HISTORIC AND DESIGN REVIEW COMMISSION

HDRC CASE NO: 2024-164
ADDRESS: 429 MADISON ST
LEGAL DESCRIPTION: NCB 746 BLK 5 LOT 7
ZONING: RM-4, H
CITY COUNCIL DIST.: 1
DISTRICT: King William Historic District
APPLICANT: John Lenz/Lenz Contractors, Inc.
OWNER: Thomas Patterson/PATTERSON THOMAS F & JANE E
TYPE OF WORK: Front porch additions
APPLICATION RECEIVED: April 10, 2024
60-DAY REVIEW: June 9, 2024
CASE MANAGER: Jessica Anderson

REQUEST:

The applicant requests a Certificate of Appropriateness for approval to construct additions to the existing front stoop to create a full-width front porch.

**PROPOSED
FRONT ELEVATION**
SCALE: 1/4" = 1'-0"

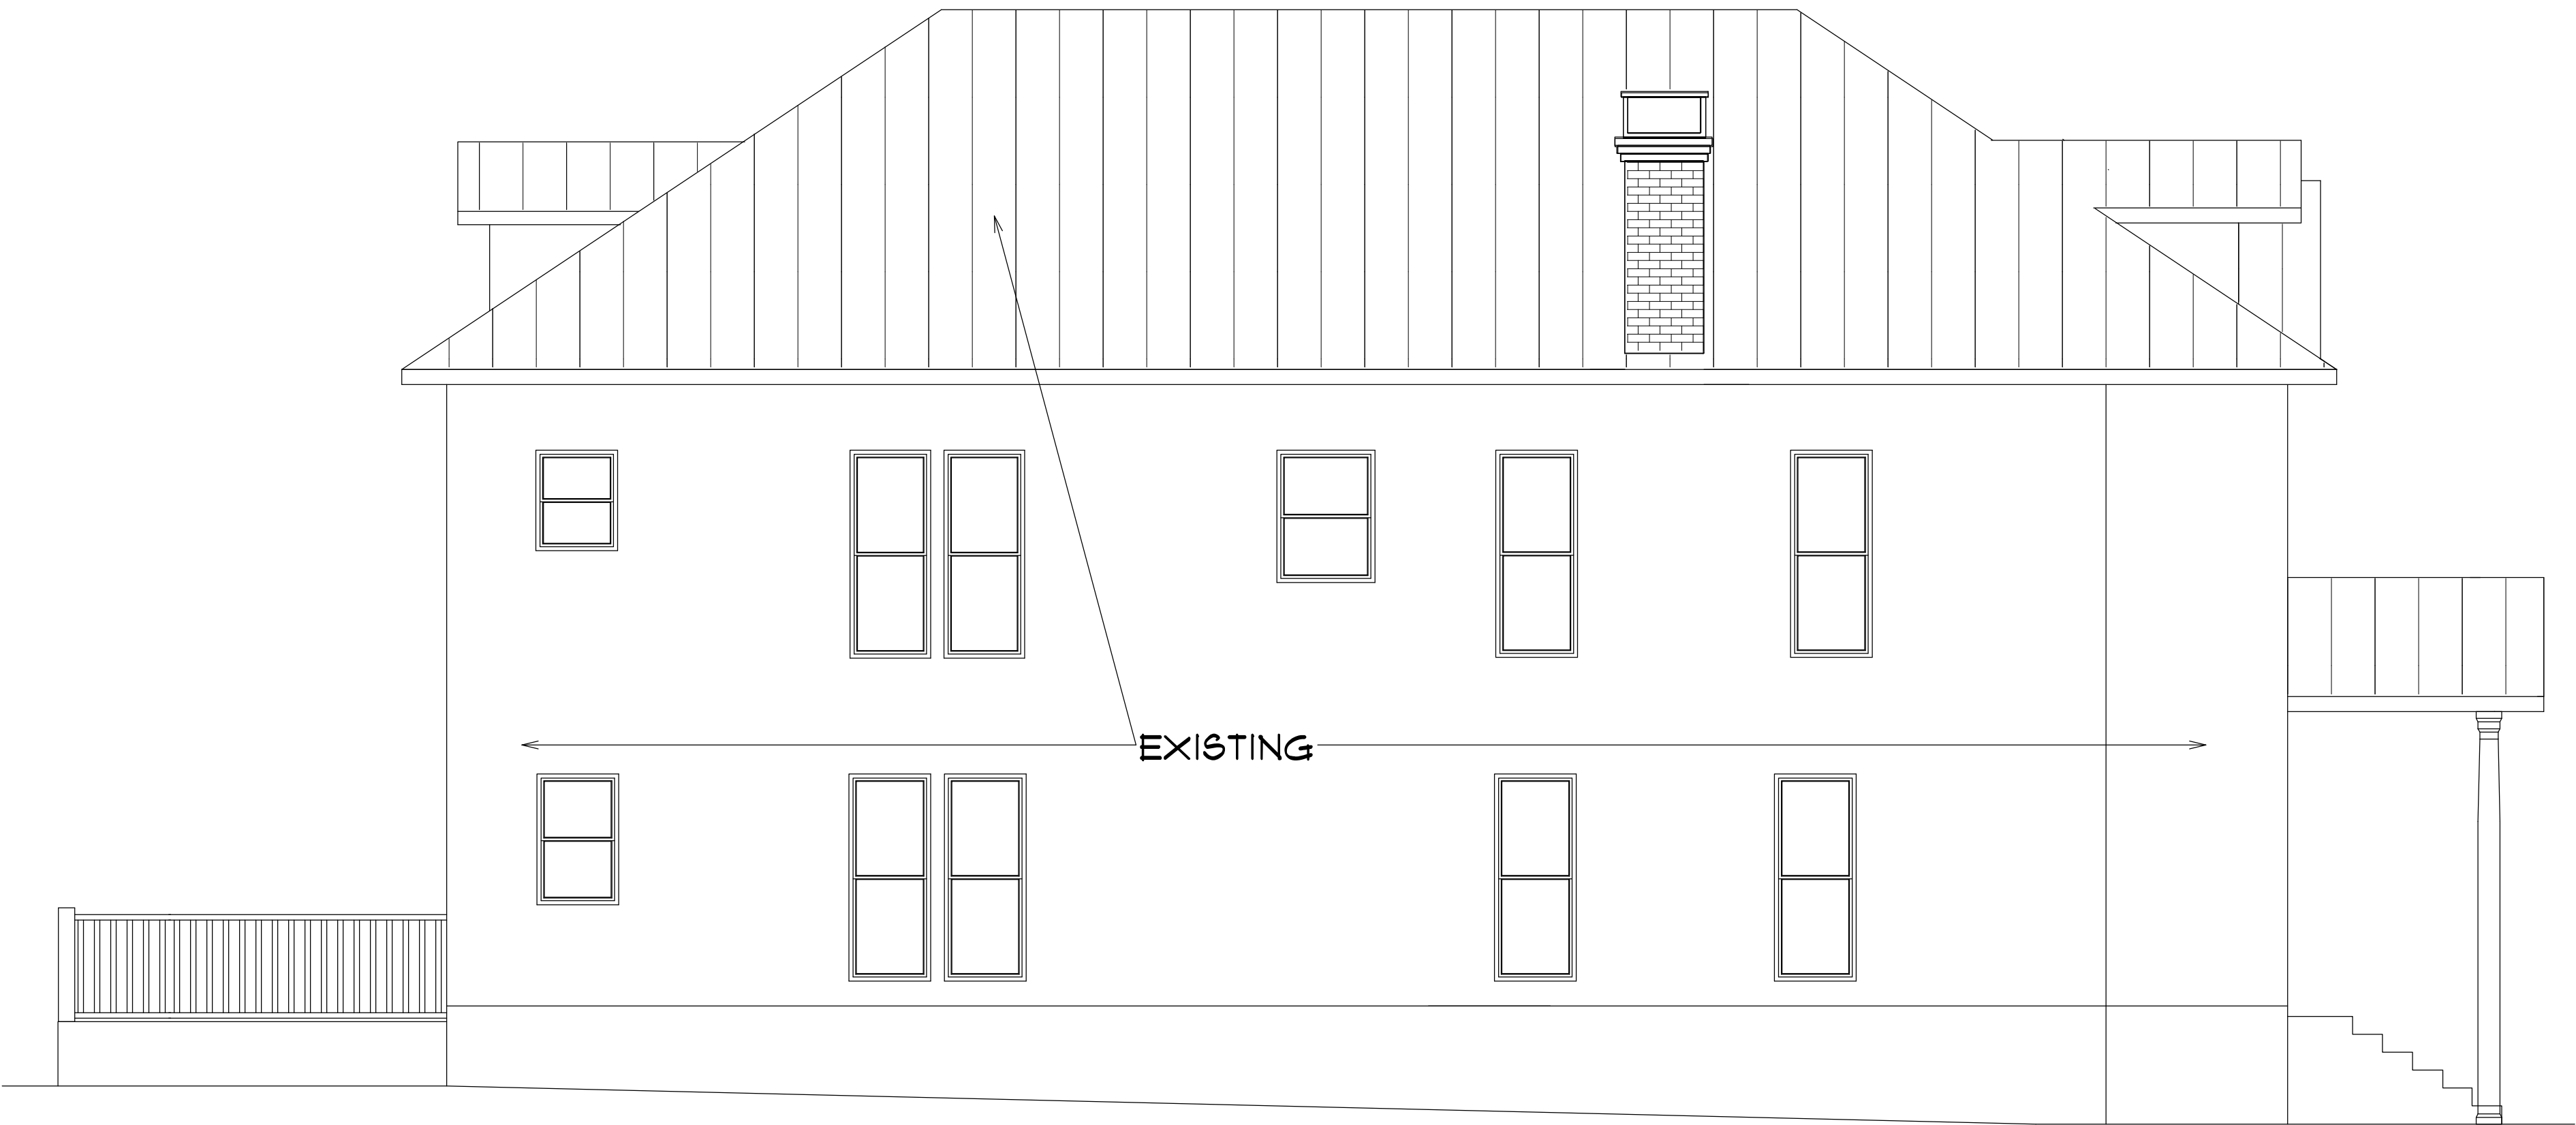
- c. FRONT PORCH ADDITION: The applicant requests approval to construct additions to the existing front stoop to create a full-width front porch. Historic Design Guidelines for Exterior Maintenance and Alterations 7.A.i says do not add new porches, balconies, or porte-cocheres where not historically present. An addition of a new porch to a front facade would not typically conform to the Guidelines. However, staff finds there is a significant loss of original materials and design elements at the front facade, and a compatible front porch design may be appropriate in this instance.

Staff recommends approval of the applicant's request to construct additions to the existing front stoop to create a full-width front porch based on findings a through c, with the following stipulations:

- i. That the applicant installs 1"x3" wood tongue and groove flooring for the patio, installed perpendicular to the facade.
- ii. That the applicant installs wood lattice to match existing skirting rather than the brick proposed.
- iii. That the applicant submits a porch railing detail to staff for review prior to the issuance of a Certificate of Appropriateness.
